**NSLPP MEETING HELD ON 6/04/22****Attachments:**

ADDRESS/WARD: 23 Victoria Street, McMahons Point (W)**APPLICATION No:** DA 230/20/2**PROPOSAL:** Section 4.55(2) Modification to DA 230/20/2 to raise the roof level of the approved roof level additions, including a higher lift overrun and introduction of new rooftop terrace.**PLANS REF:**

OWNER: Selva Nithan Thirunavukarasu**APPLICANT:** Studio Barbara**AUTHOR:** Kim Rothe, Senior Assessment Officer**DATE OF REPORT:** 30 March 2022**DATE LODGED:** 7 September 2021**SUBMISSIONS:** Nil (0)**RECOMMENDATION:** Approval

Figure 1: Proposed attic/new terrace plan

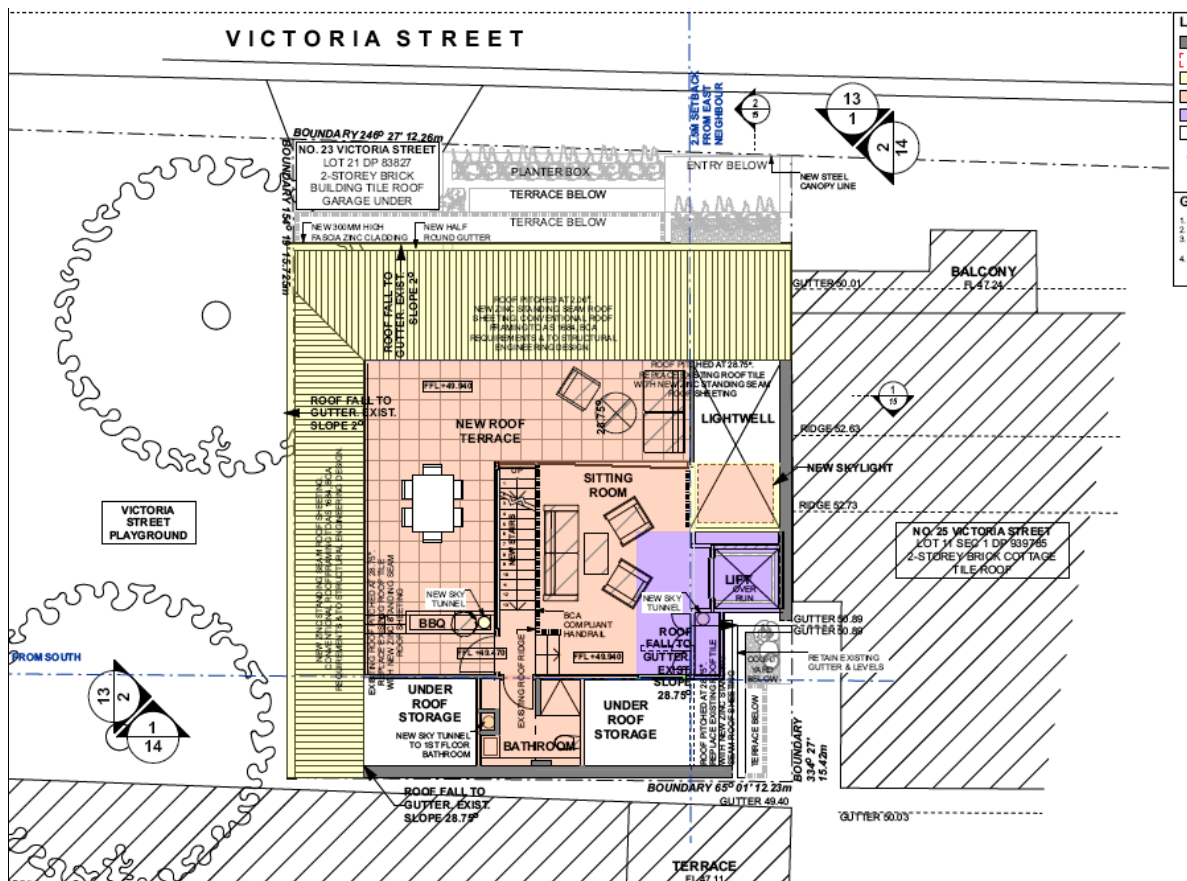
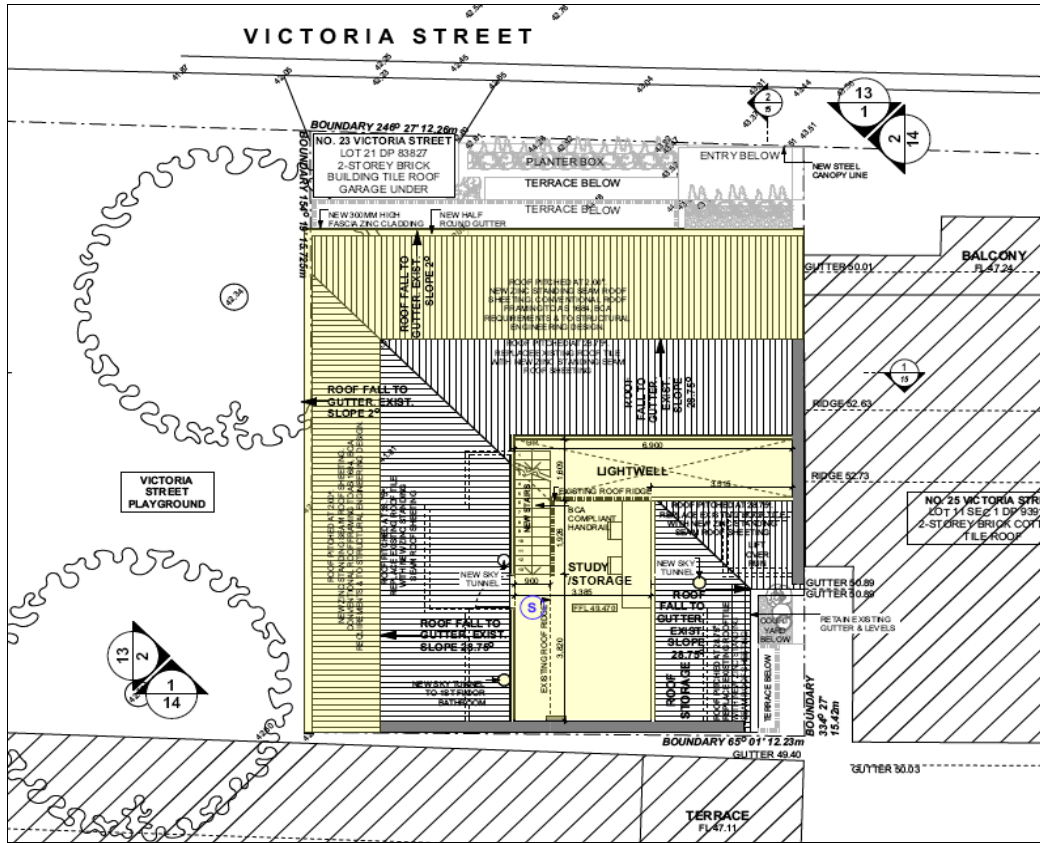
The modification proposal involves altering the as approved attic level plan. The approved space included stair access to a study / storage area. The subject proposal is sought to alter the space into a sitting room with a newly proposed outdoor roof terrace and new bathroom. The lift incorporated into the other levels will be extended to allow for access to this new extended level. There will also be a new lightwell over the entry door area. The roof level and shape has been altered to improve the amenity and functionality of the space.

- The approval included a *new* study/storage room with stair access within the roof space however this space had a racked ceiling and no outdoor space. The subject modification expands on this approval by creating the necessary floor to ceiling height clearance but fundamentally does not propose a new level to the building not previously approved.

- The internal area of the roof level modifications is the same as that approved but the roof form in altered to make the area more properly habitable in terms of floor to ceiling heights than the ancillary space as was approved.

Figure 3: Proposed modified street elevation

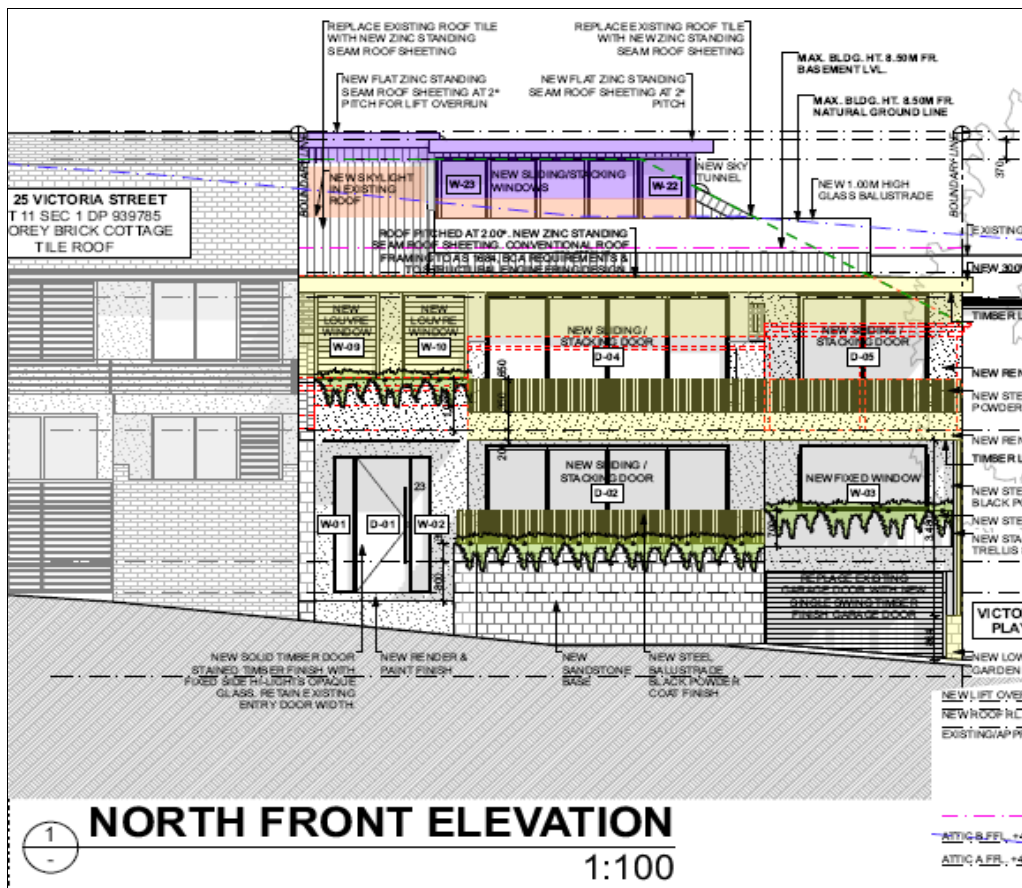
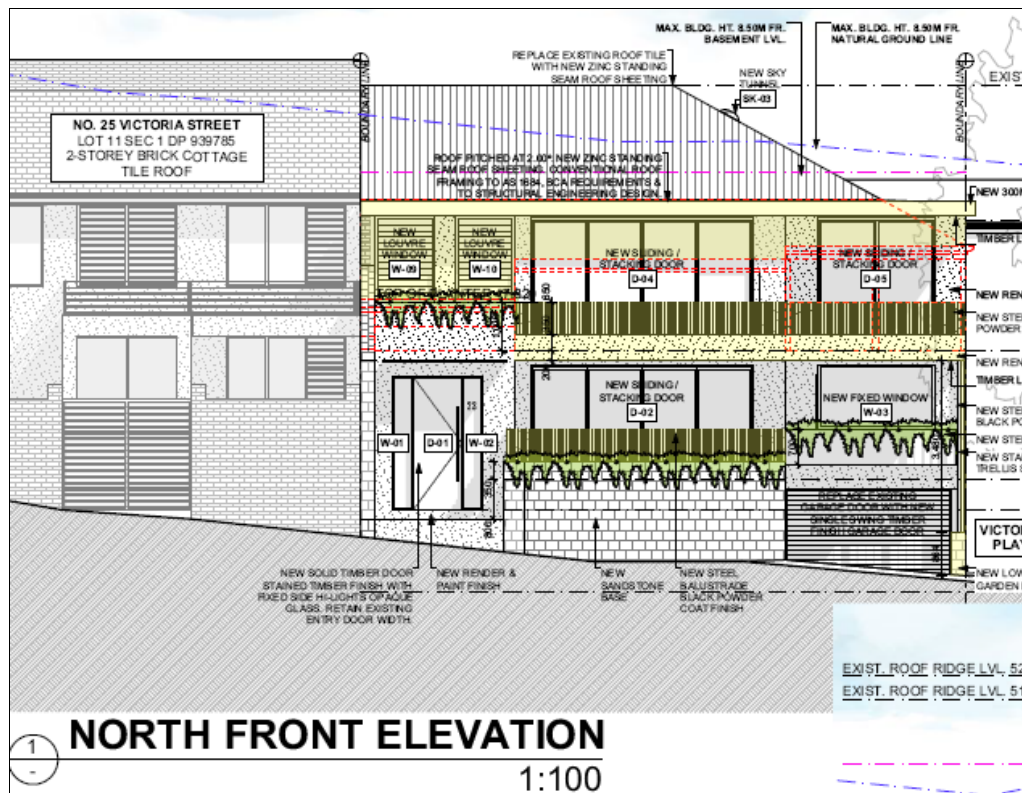
<p>Built Form Character</p> <p><i>O1 To ensure that the design of new buildings reflects and reinforces, or is complementary to, the existing character of the locality.</i></p>	<p>Yes</p>	<p>Overall, the external alterations do not significantly alter the existing character of the building.</p> <p>The proposed S4.55 changes achieve the aims and objectives of NSLEP and NSDCP and are respectful and complimentary to those heritage items in the vicinity of the site and adjoining HCA.</p> <p>For this reason, the proposal as modified is acceptable in this regard.</p>
<p>Dwelling Entry</p>	<p>n/A</p>	<p>There is no change to the dwelling entry as approved in this modification.</p>
<p>Roofs</p>	<p>Yes</p>	<p>The pitched roof is to be partly modified to accommodate the S4.55 proposal. Part of the pitched roof is maintained to the rear of the building as well as to part of the front elevation in front of the lift. The balustrade is setback from the edge of the building to reduce its prominence.</p> <p>The proposal remains compatible with the character of the area being similar in bulk and scale to surrounding developments.</p> <p>The development responds to the siting of surrounding dwellings and is compatible with the footprint and height of adjoining developments. The additional height is considered minimal as it occurs at a central point on the site which is setback from the front boundary alignment.</p> <p>The upper level remains no more than 50% of the floor area immediately below it. The modifications are deemed acceptable in this regard.</p>

Figure 5: Proposed Elements over Building Height Limit (8.5m). Height line is projected in blue in the figure, the as approved line of the roof in the original application is shown in green

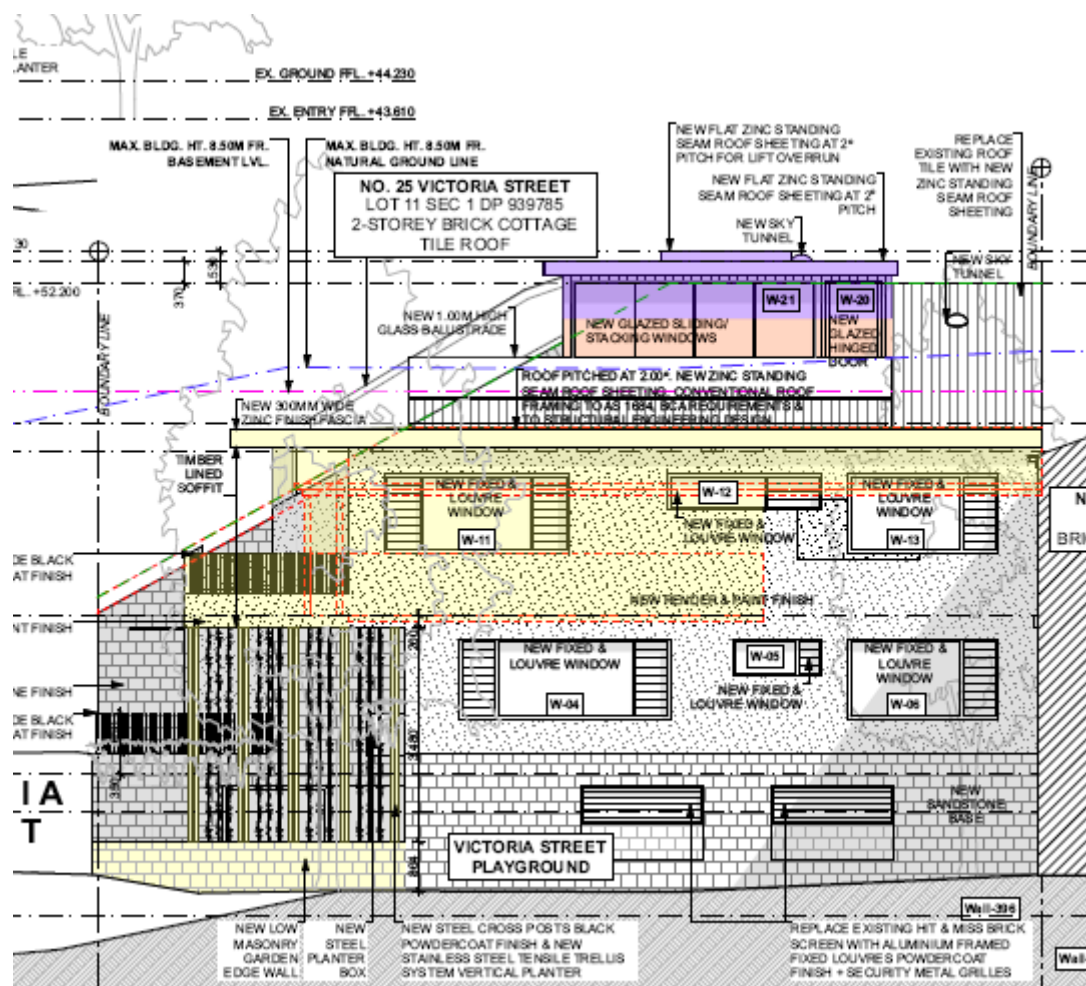
The height of the has been amended to be 10.26 metres to the main new amended roof and lift overrun structure overrun and represents an amended maximum variation of 20.7%.

The proposed development adequately accounts for the site's topography with maximal breaches occurring at the plant and minor extended roof structures over. The newly proposed roof terrace is only just in breach at its balustrade edge and the floor of the terrace is within the height limit. The altered roof and plant are also in breach however the modifications do not make any material breach to the extent of previously approved height variations.
